Re: MVC approval of DRI 689-M (The Yard Campus Master Plan Modification)

Alison Kisselgof Blake Middleton Oct. 21, 2022
DRI 689 – The Yard Campus Master Plan
Updated Conditions Following DRI 689-M Approval

Subject: Re: The Yard modifications - MVC approval letter

OCTOBER 2022 | PROPOSED SITE PLAN

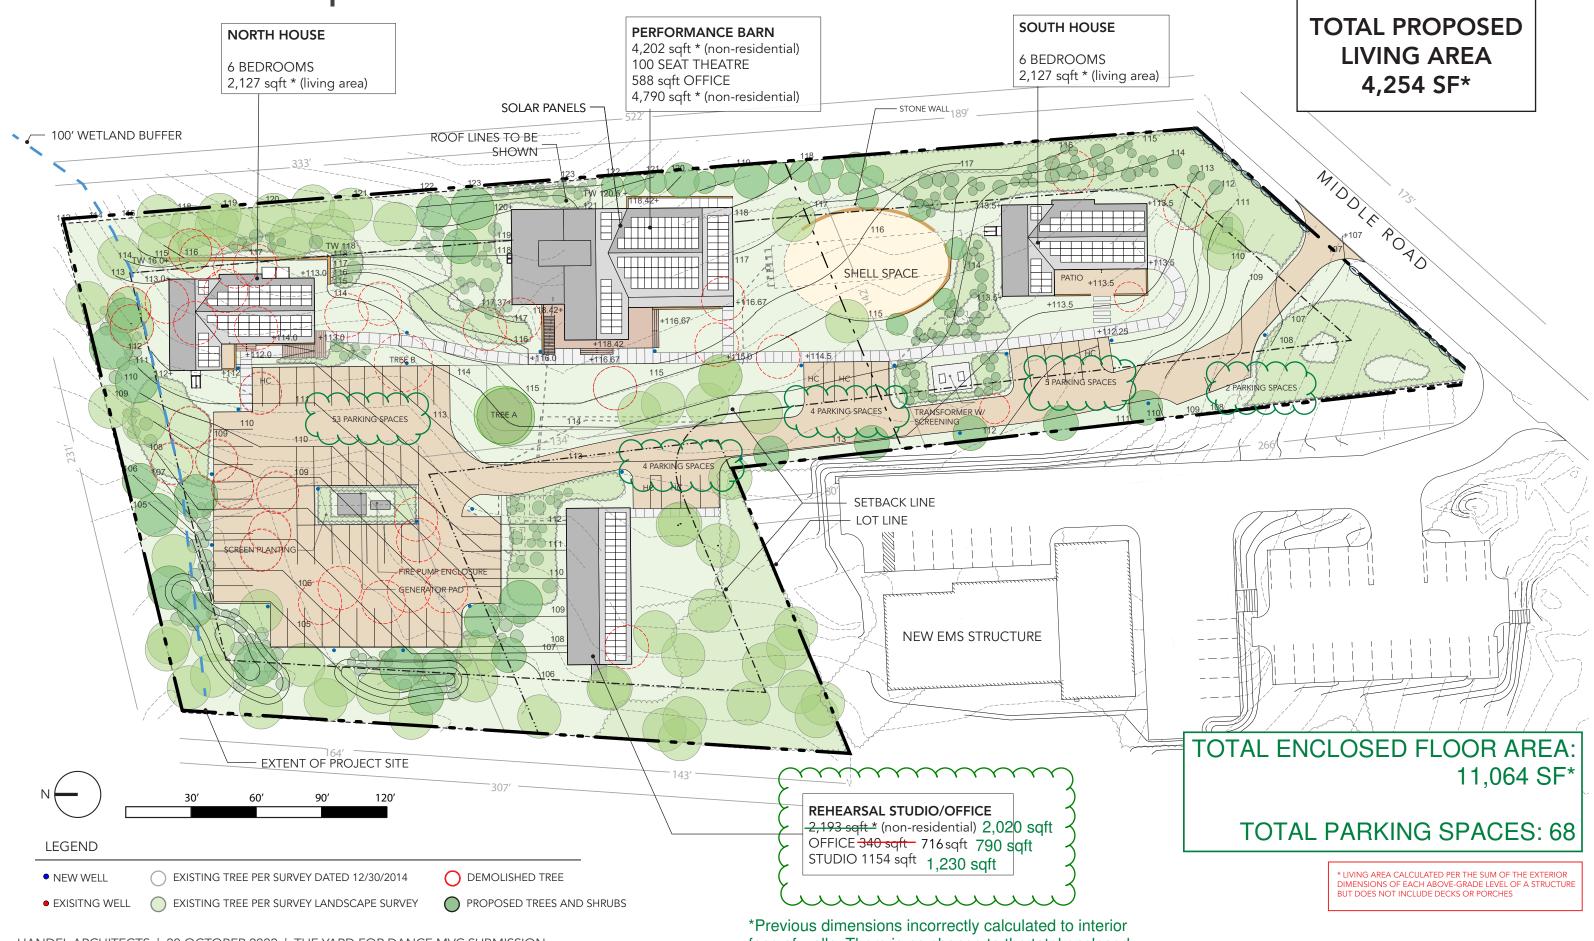
1. There is an error regarding the summary of revised total parking. The final plan indicated 68 spaces, not 66. Its possible the two parking location at the south end of the driveway were not counted. We respectfully request that the letter be corrected to reflect the actual parking count.

3. Per your request for additional information, the total enclosed floor area of the October 2022 plan is 11,064 square feet. Also, we discovered an error on the Site Plan which had erroneously calculated the floor area of the Rehearsal Studio/Office to the inside of the spaces, not to the exterior face of wall per Chilmark Zoning definition. We have corrected that information. Note that the size, use, location, and total floor area of the Rehearsal Studio/Office Pavilion has NOT changed since the MVC-approved 2019 Site Plan. It is now, and was then, 2020 square feet enclosed area.

To help clarify, I have enclosed an annotated October 2022 Site Plan indicating those corrections, in green text or bubbles.

*Previous dimensions incorrectly calculated to interior face of walls. There is no change to the total enclosed floor area from approved 2019 site plan for this structure.
